**2ND STREET WIDENING  
BONDURANT, IOWA**

**ADDENDUM NO.2**  
February 13, 2025

SHEET NO.  
**M.02**

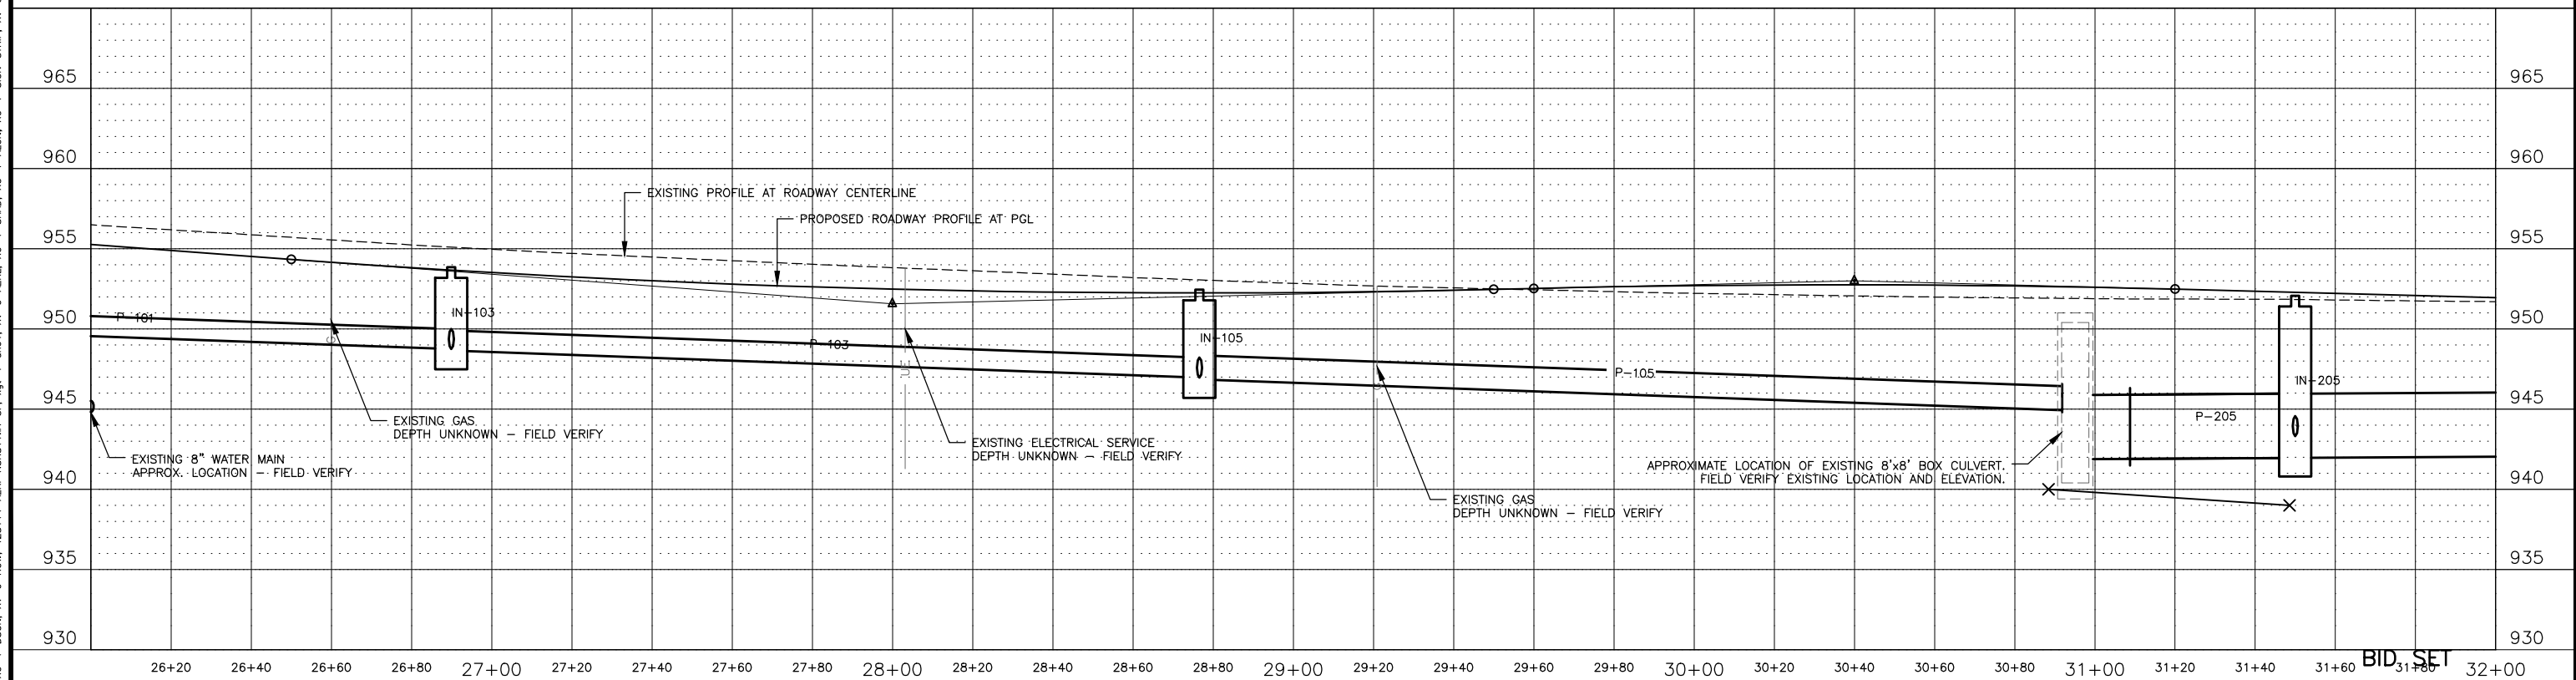
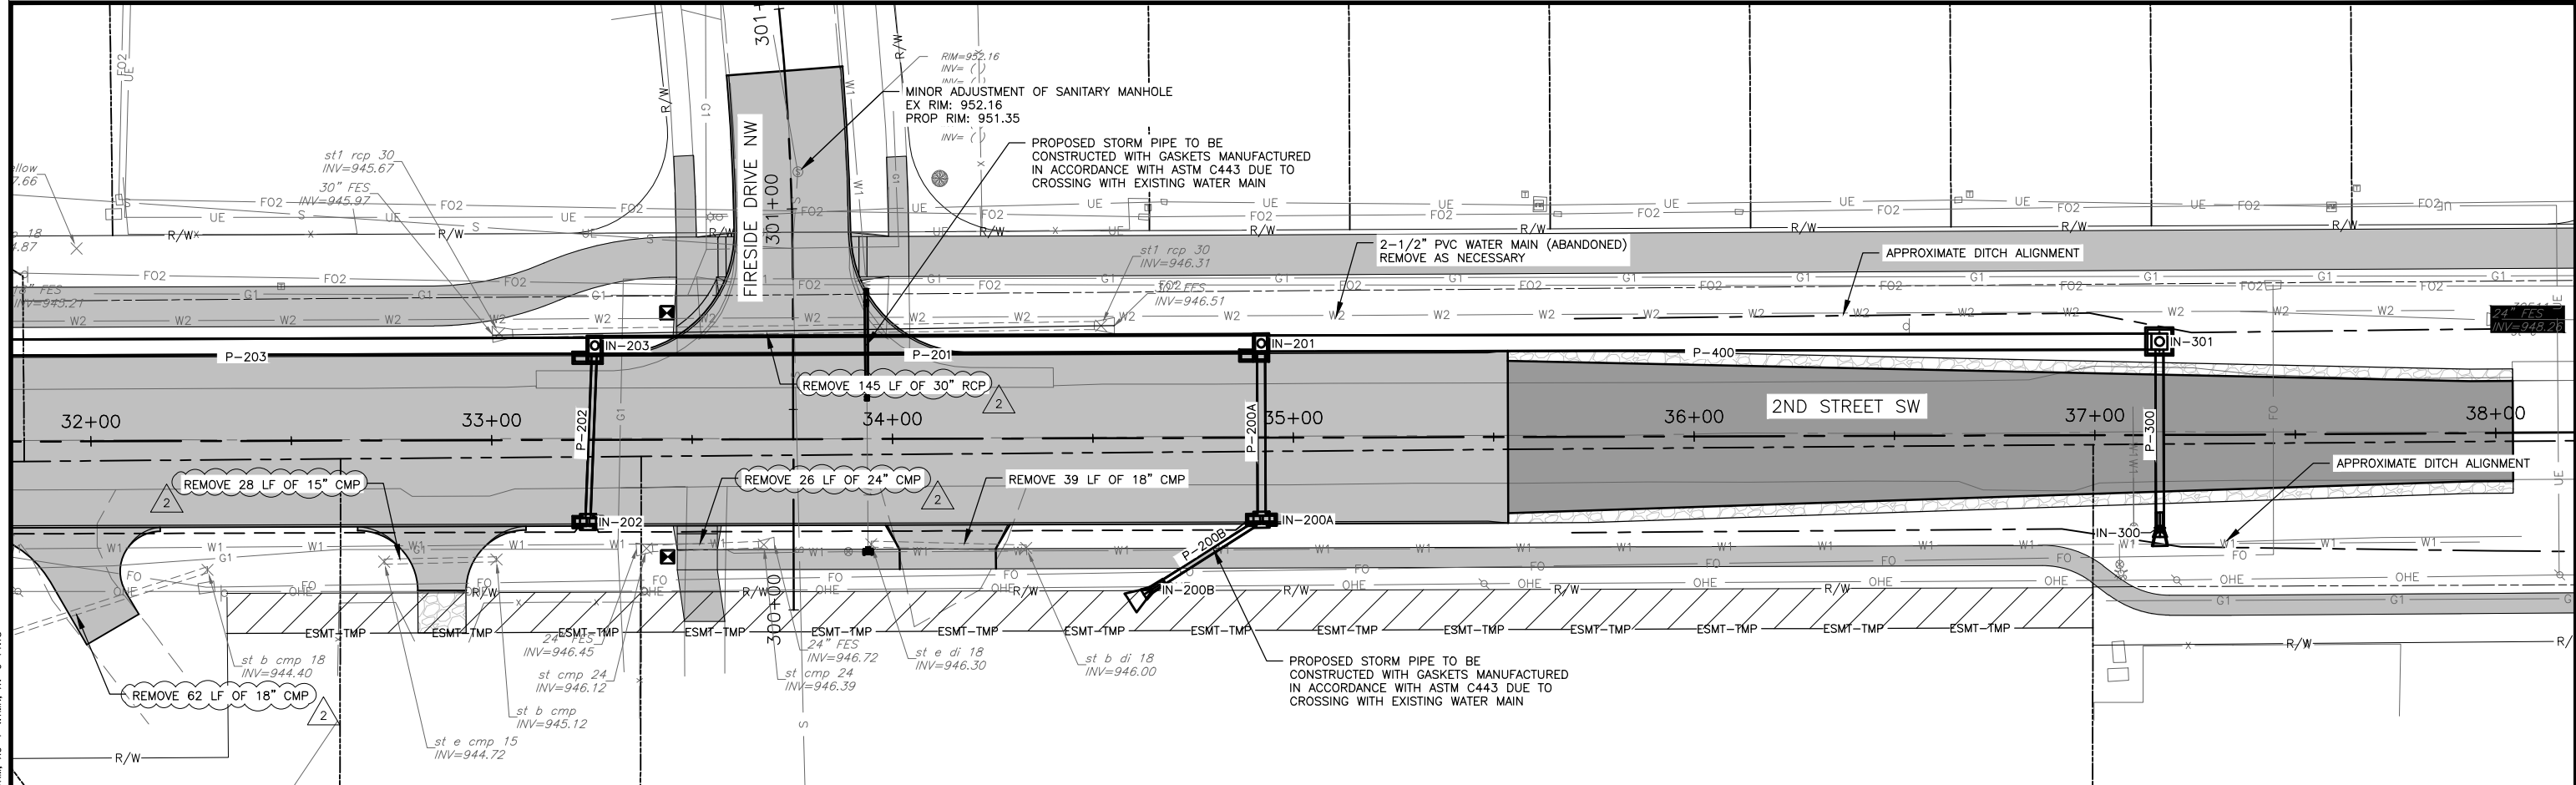
- d. **REPLACE** Sheet M.02 with the attached – Add subdrain cleanout; Adjust storm sewer removal quantities as indicated.
- e. **REPLACE** Sheet M.03 with the attached – Adjust storm sewer removal quantities as indicated.
